# SB-10054544-6156

**BULLETIN NUMBER:**  
IB12-N-001B

## No Crank/No Start, No Scan Tool Communication - Extreme Cold Weather

2007 - 2009 Chevrolet or GMC W3500/W4500/W5500  
2007 - 2015 Isuzu NPR/NPRHD/NQR/NRR

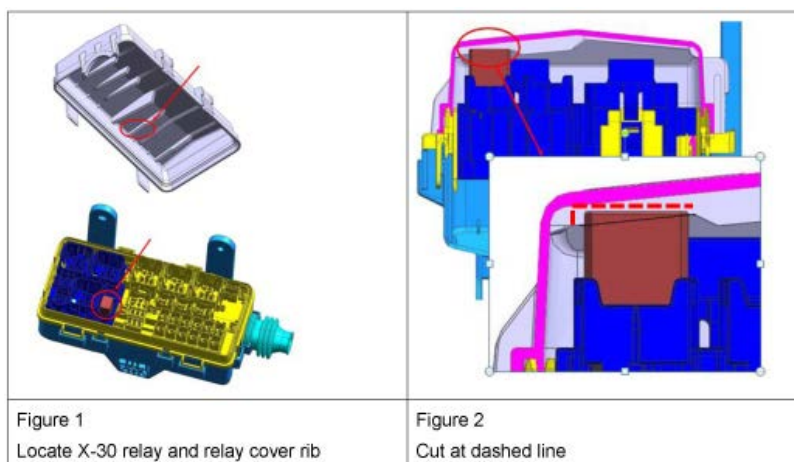
1. Remove relay box cover.
2. Remove the original ECM Main Relay in location X-30.
3. Install the new relay at location X-30.
4. Locate the relay box cover rib as shown in figure 1.

5. Trim the relay cover rib approximately 3 mm to provide clearance for the new relay.

6. Install the relay cover and confirm it seals properly. If the cover does not close properly, trim additional material from the cover until it seals.
